Project:	Apex Cemetery Remediation	RFQ No.:	2021-RFT-013
Addendum No.:	1	No. of Pages:	5
Doc. No.	N/A	Date:	June 16, 2021

CITY OF IQUALUIT
IQUALUIT APEX CEMETERY REMEDIATION
ADDENDUM 1
GRANULAR BURIAL COVER

SHEET NO.
A01

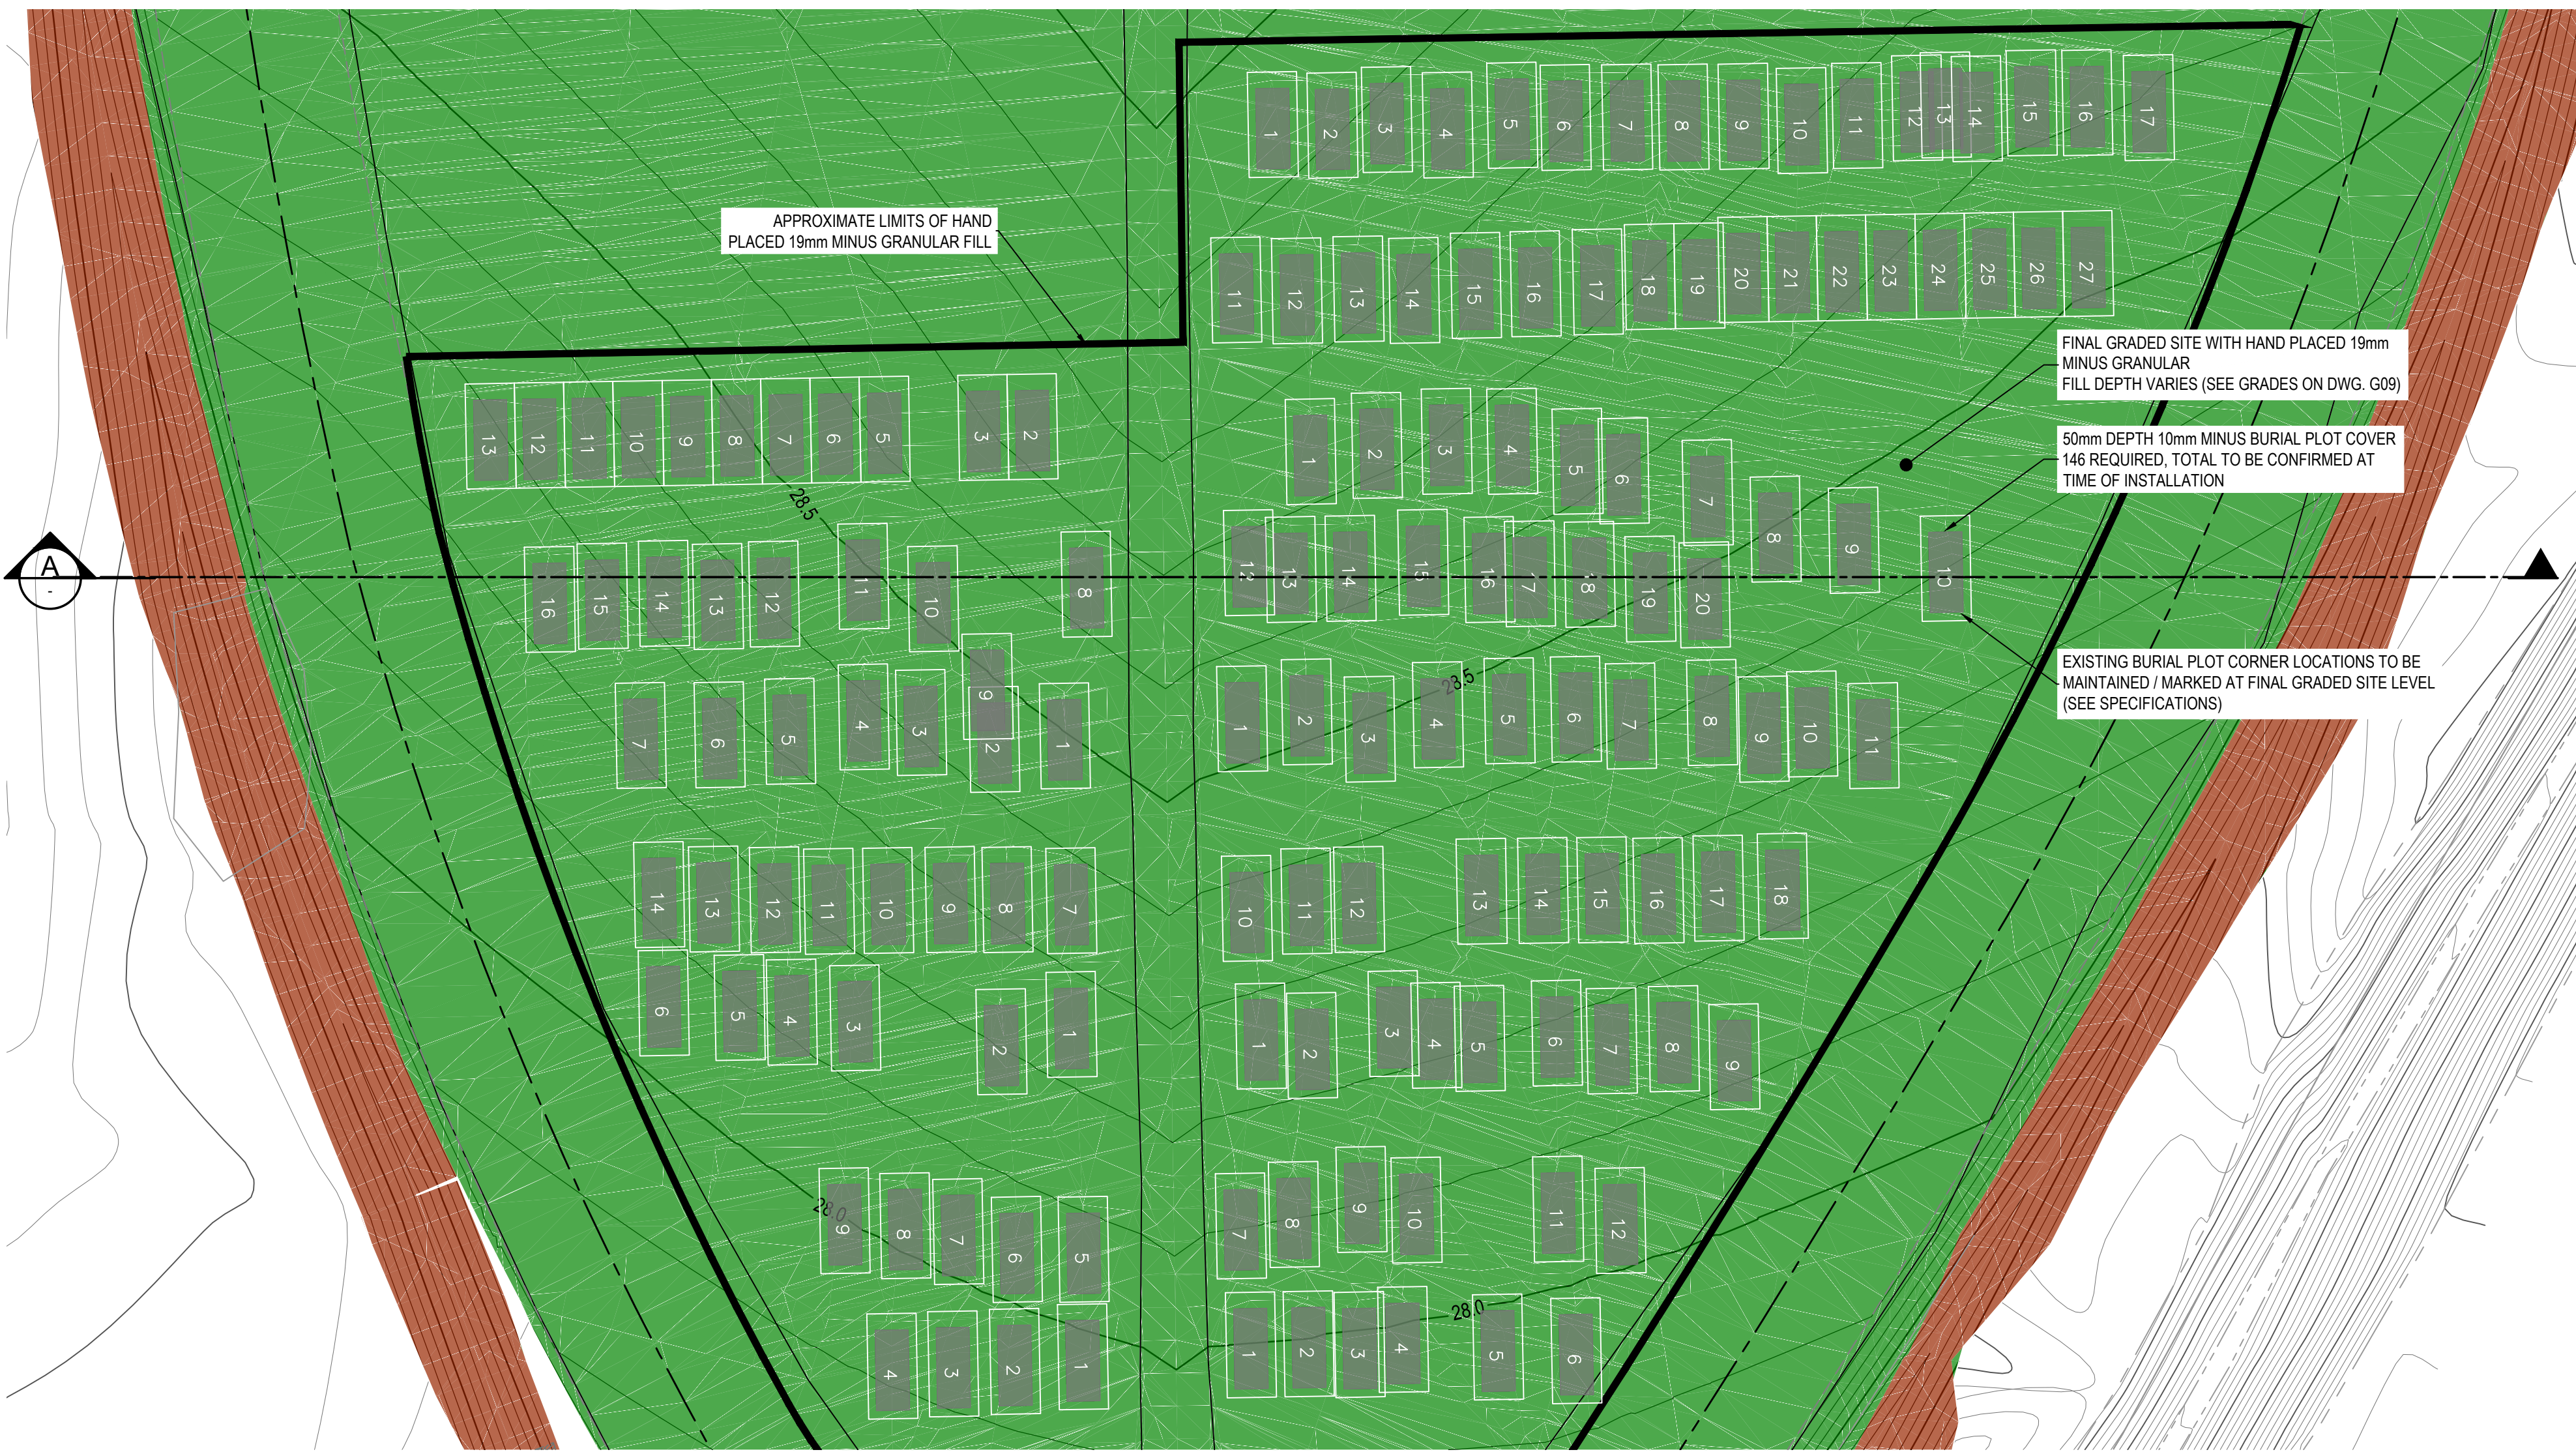
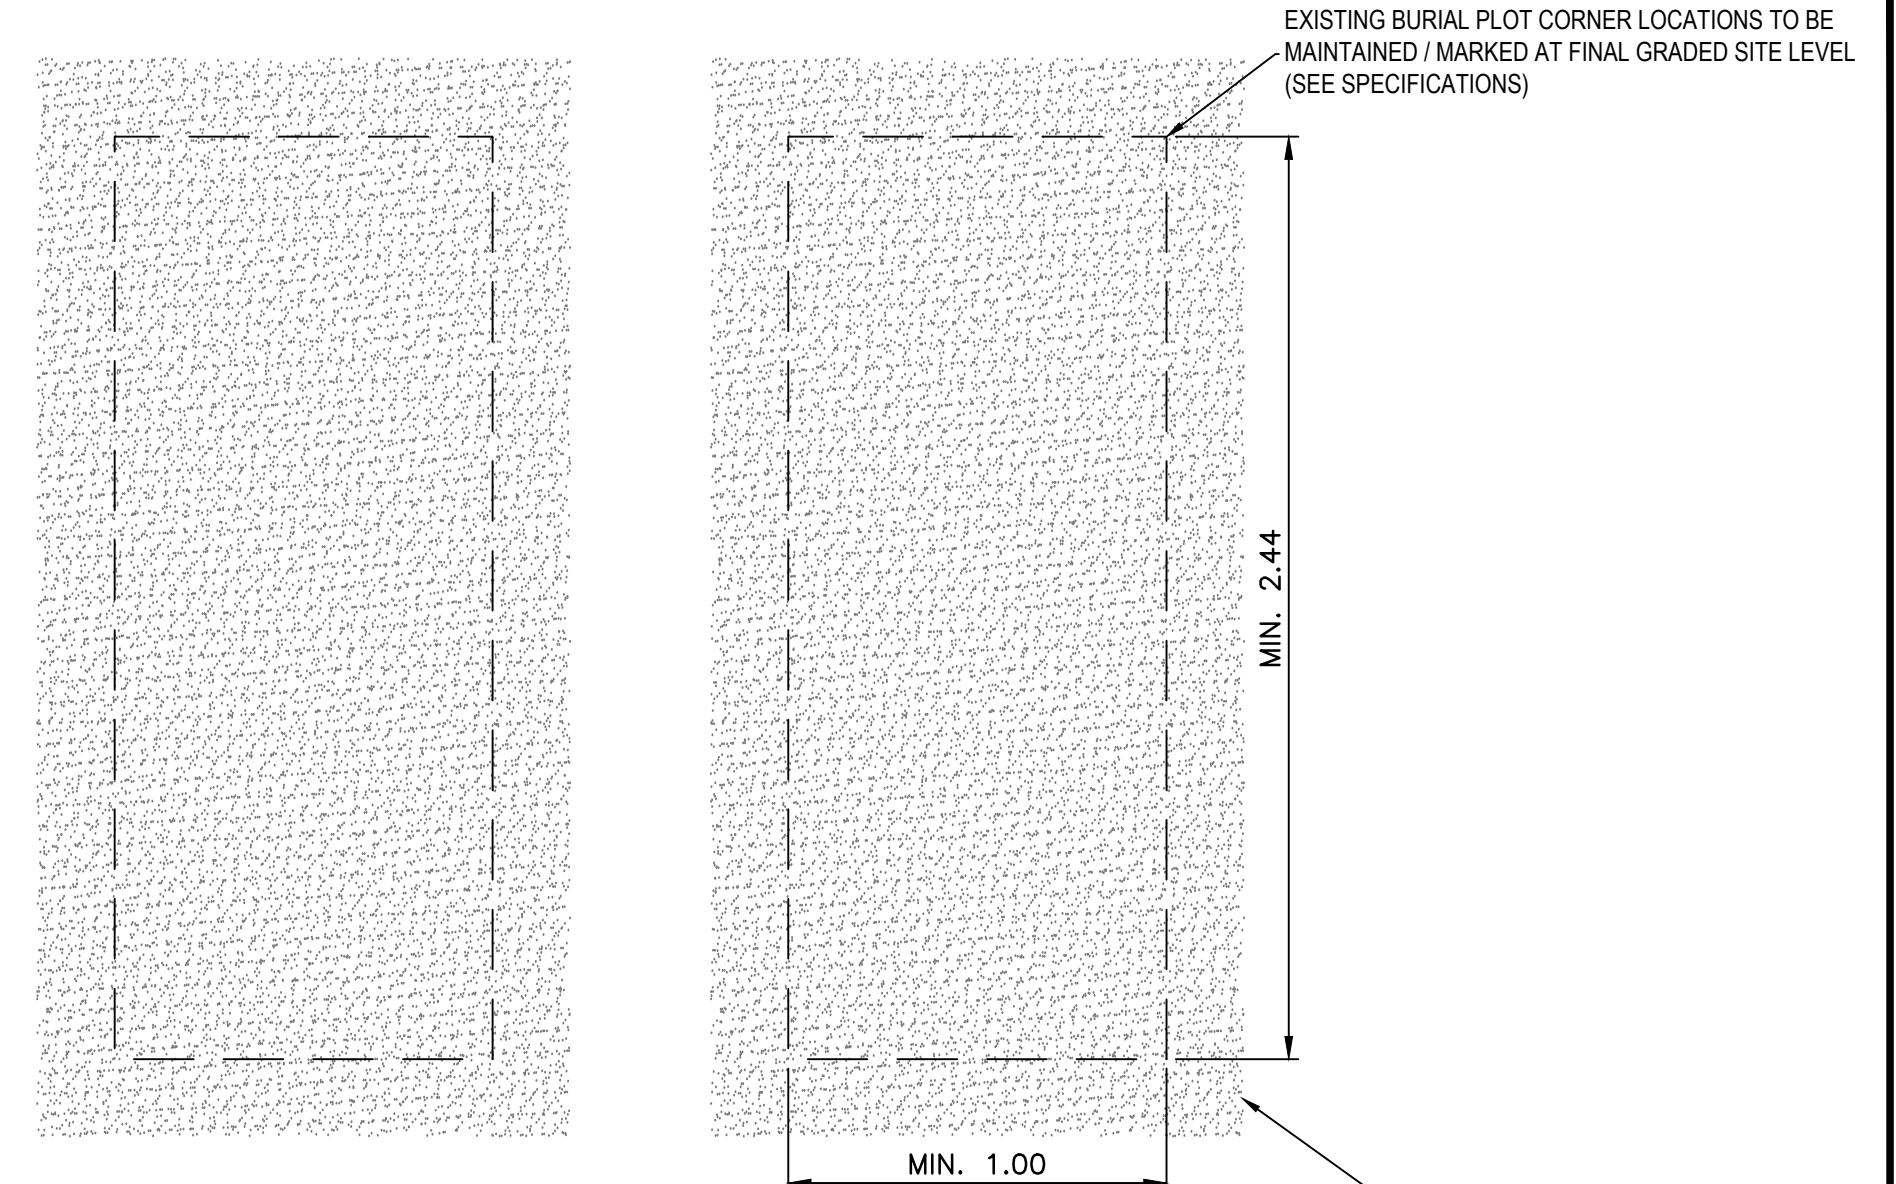
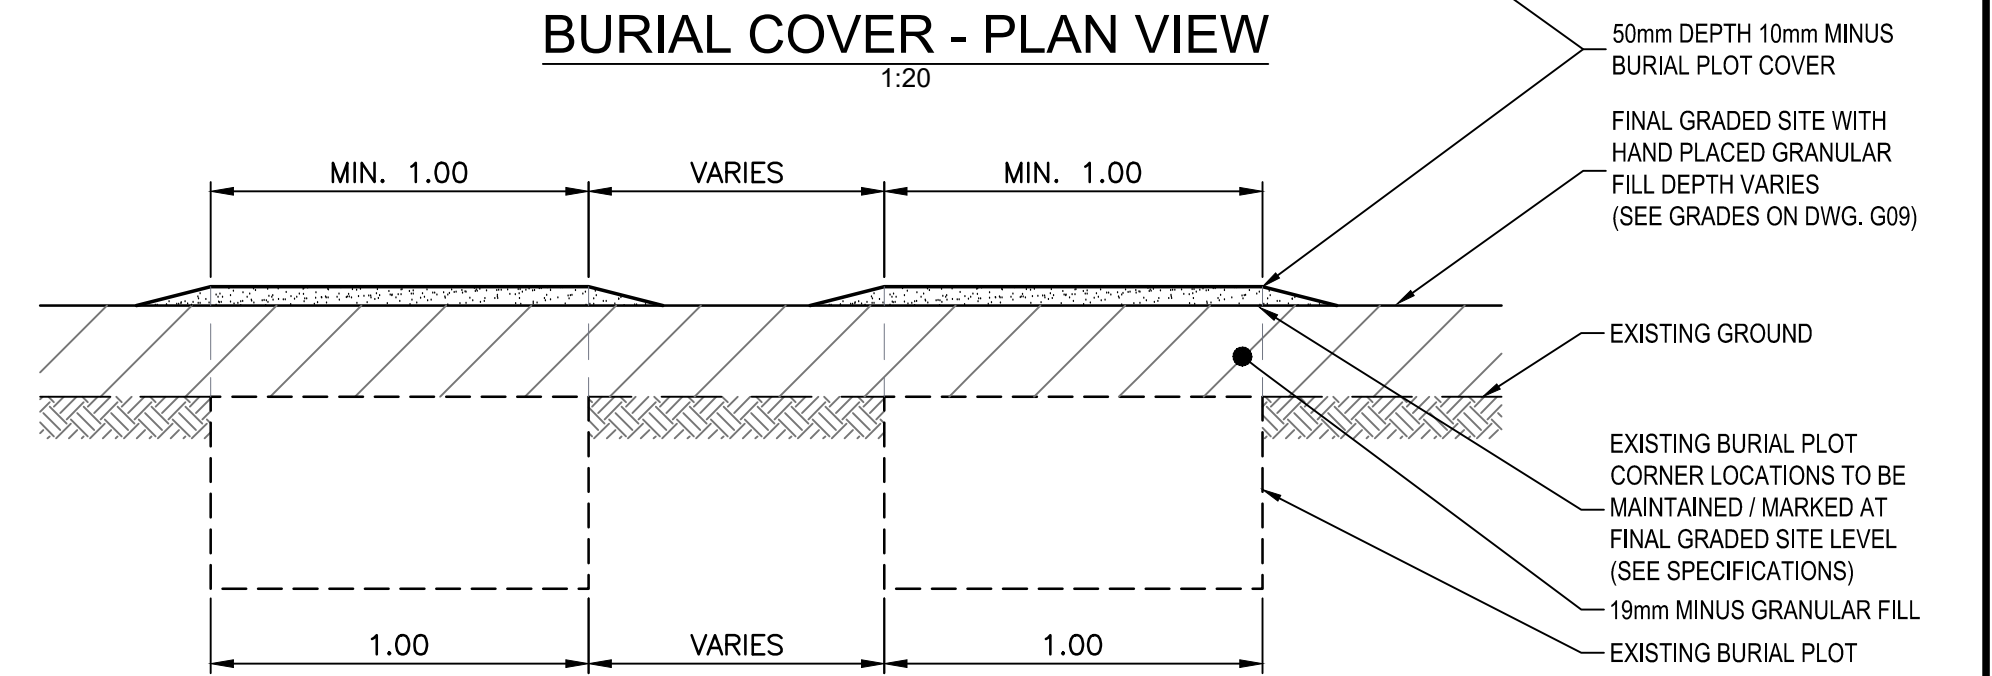
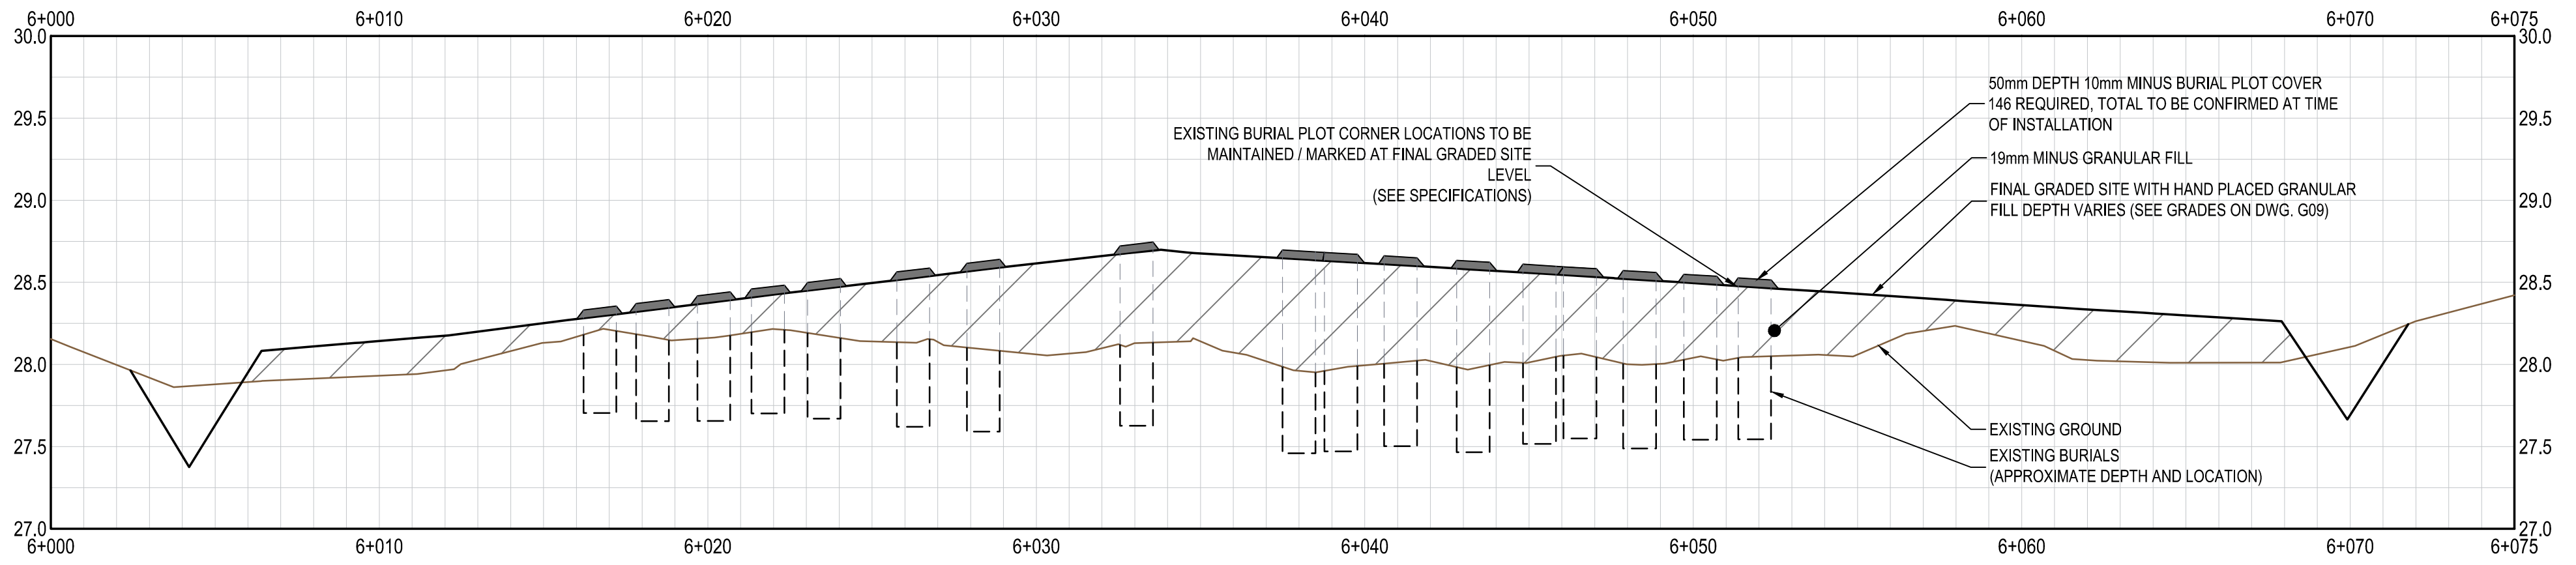
1.2	The Contractor is to provide a unit rate for the additional provisional item of adding a 10mm granular material over all of the existing burials once the site grading is complete. The Contractor is to use the updated Appendix B - Cost Submission Form attached. Plan, profile and section views of the provisional additional work is provided on Drawing No. A01 (attached). This is to include the supply, haul, placement, and compaction of a 10mm granular with the following gradation:

10 mm Minus Crushed Gravel	
Sieve Size (mm)	Percent Passing by Weight
12.5	100
10.0	90-100
5.0	90 max
2.5	32-49
0.080	2-10
